MANUAL CHANGES

Model Number: 141T
 Date Printed: June 1976
 Part Number: 00141-90914

Figure 2.
Low Voltage Schematic
8

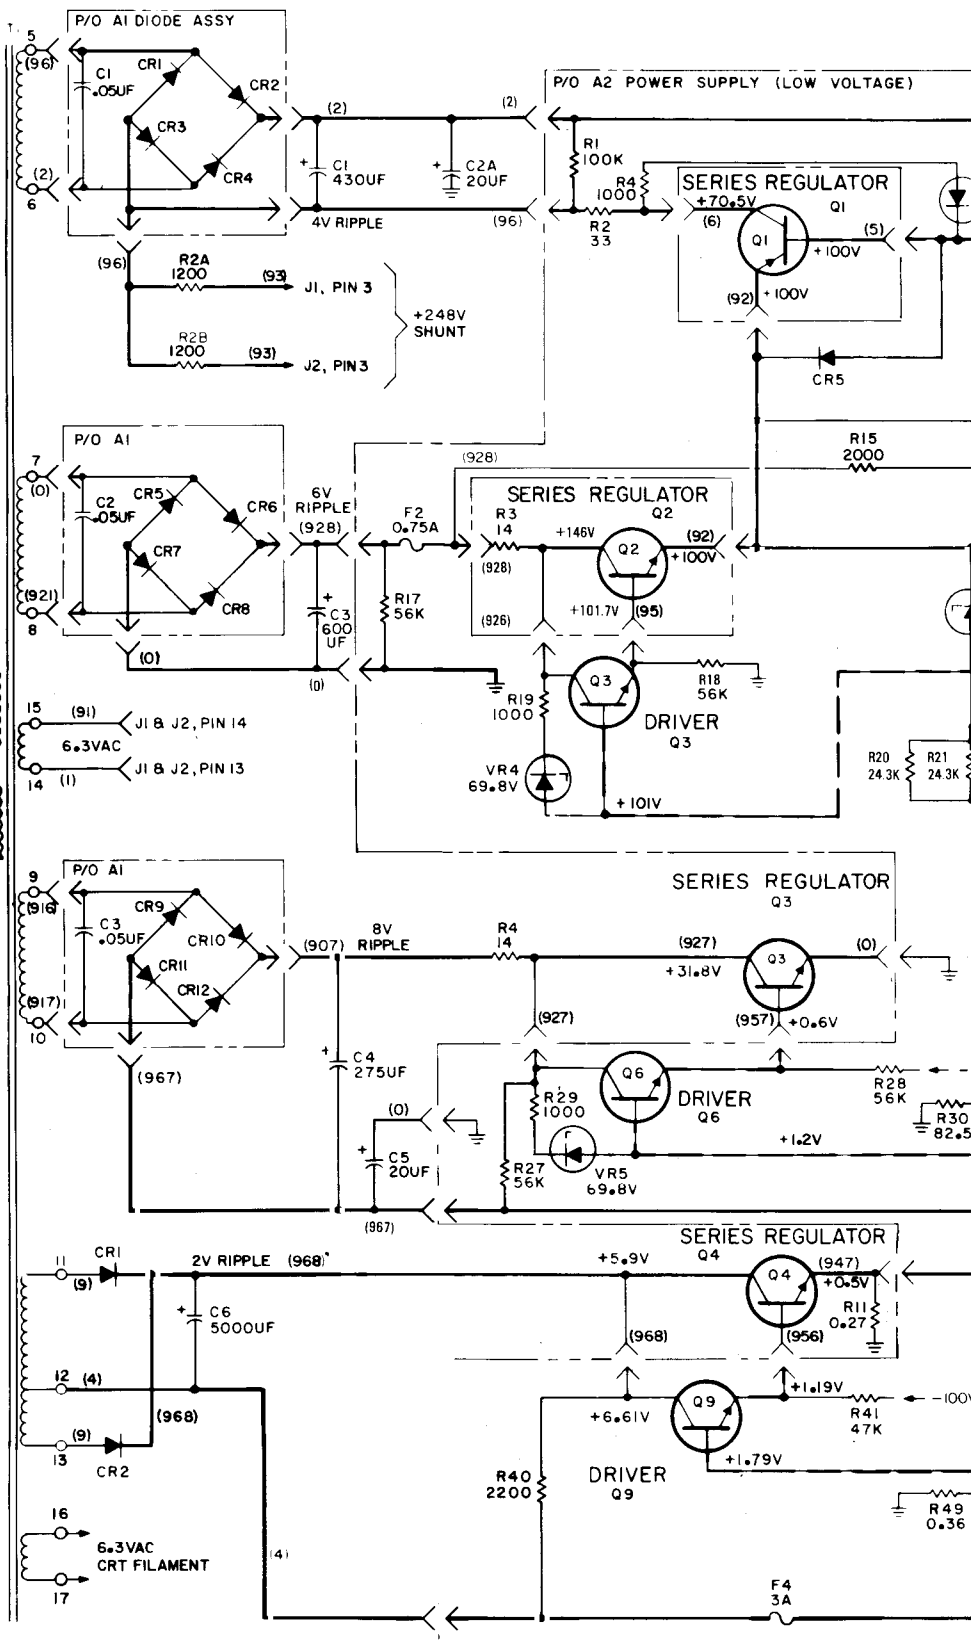
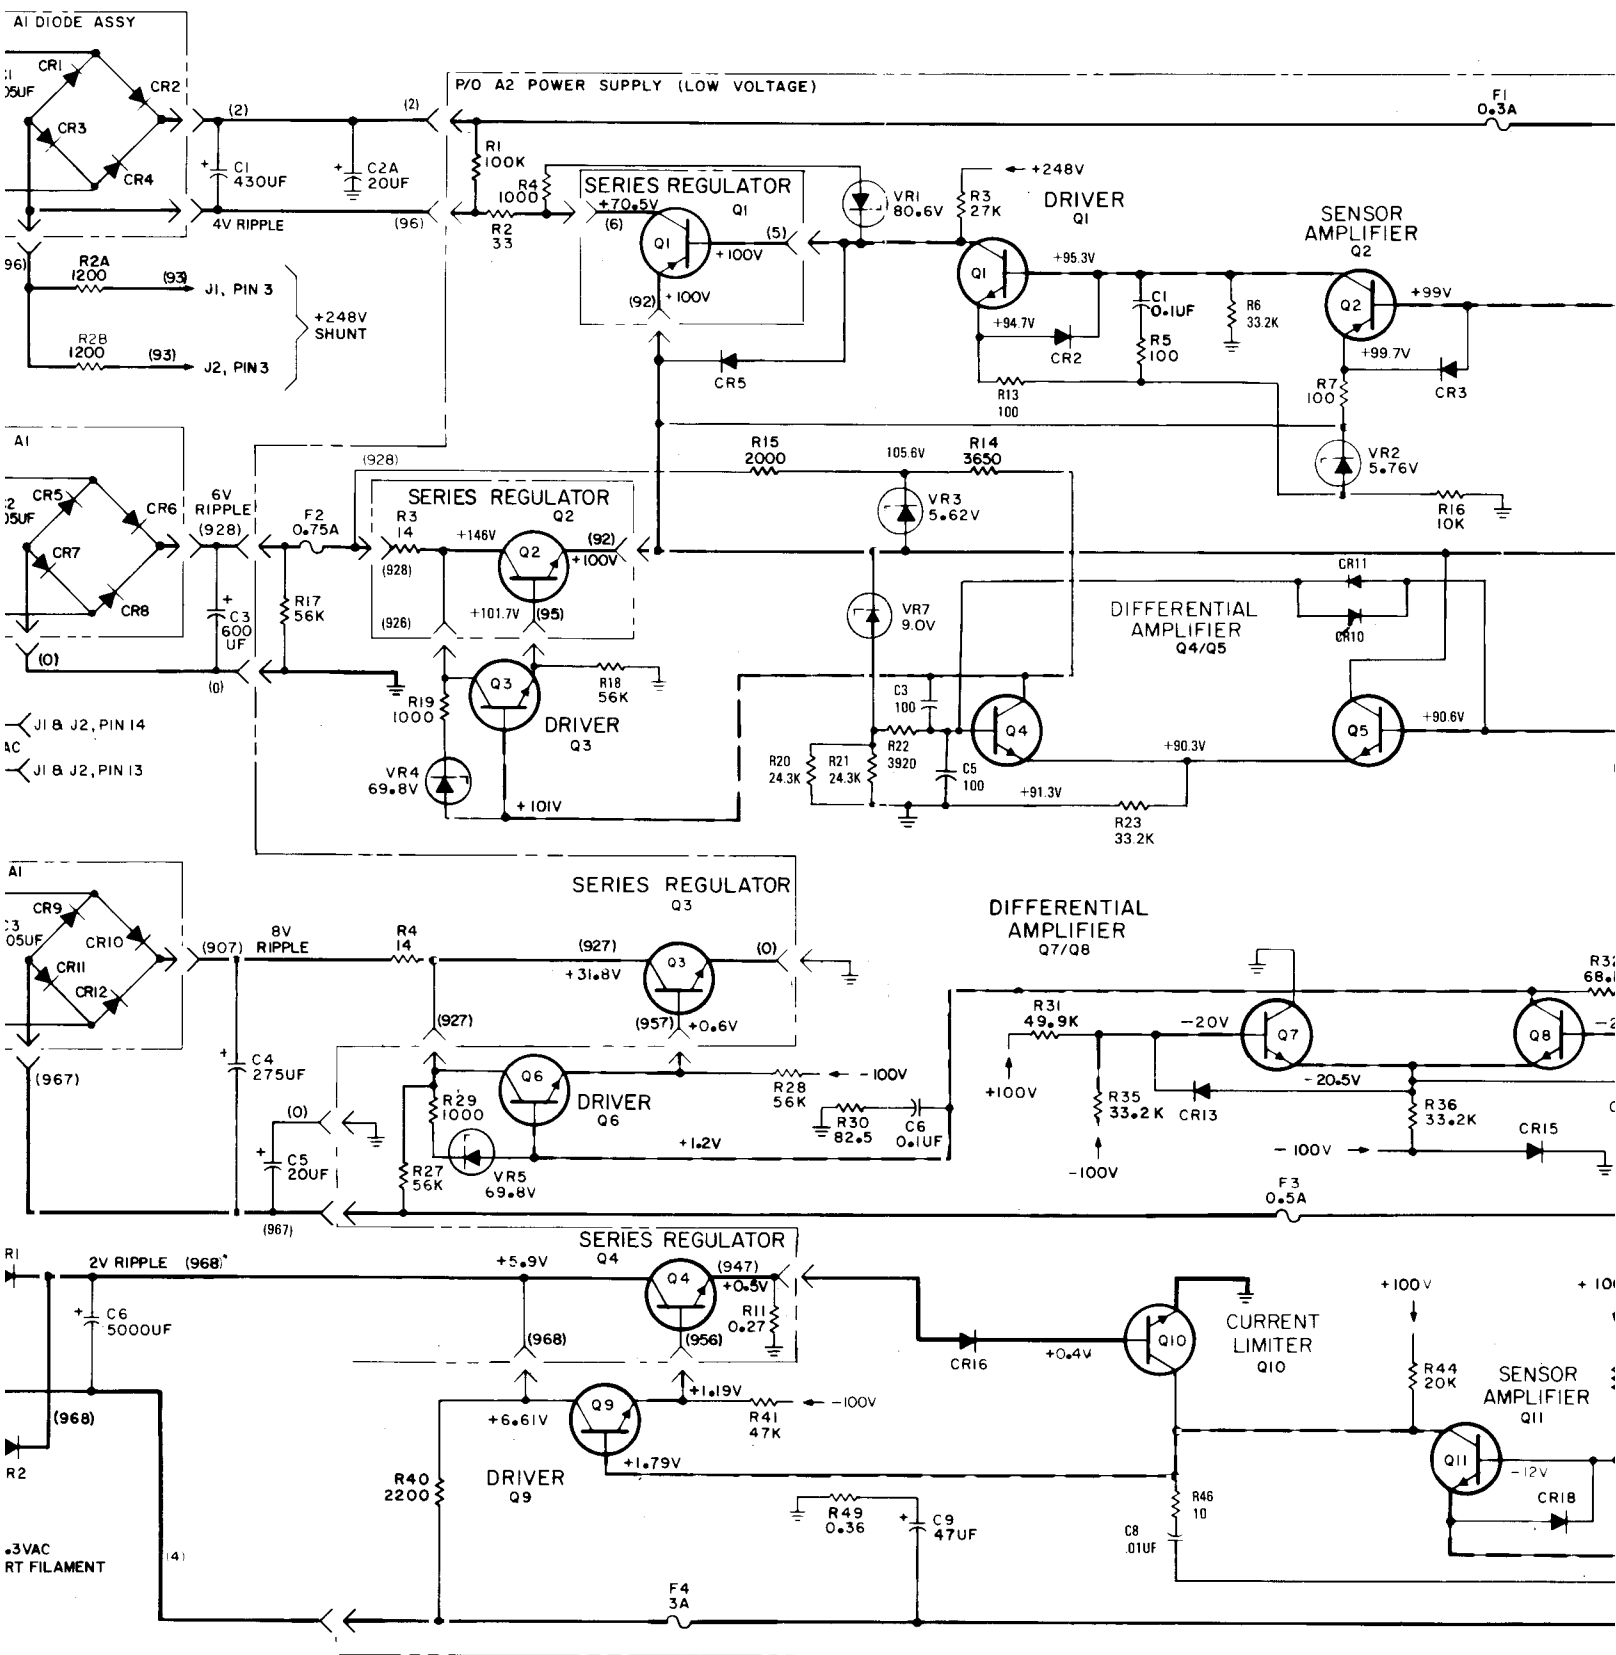
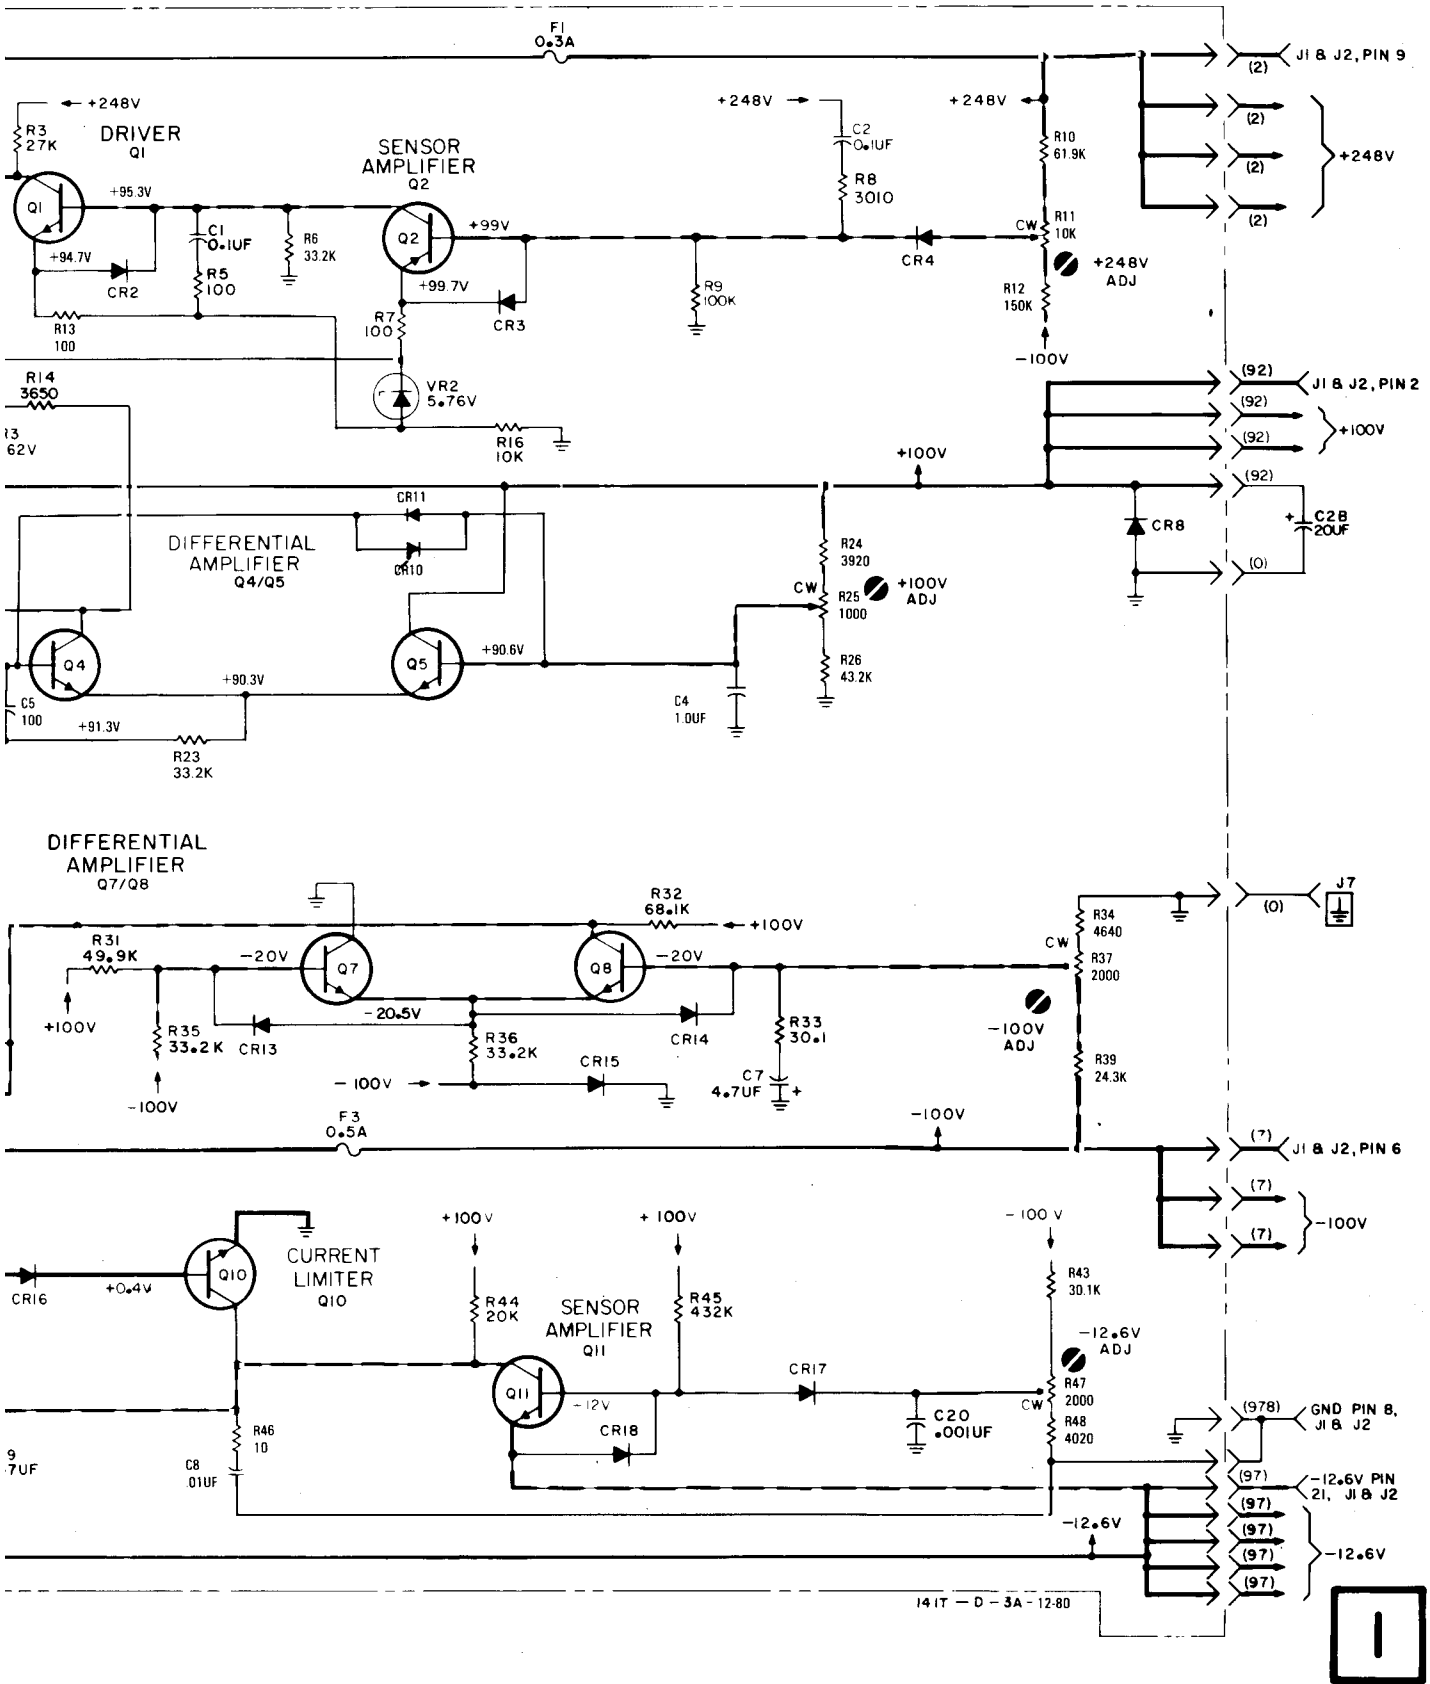
Figure 8-10. Low Voltage Schematic (page 8-15),

Replace with Figure 2 of this document.
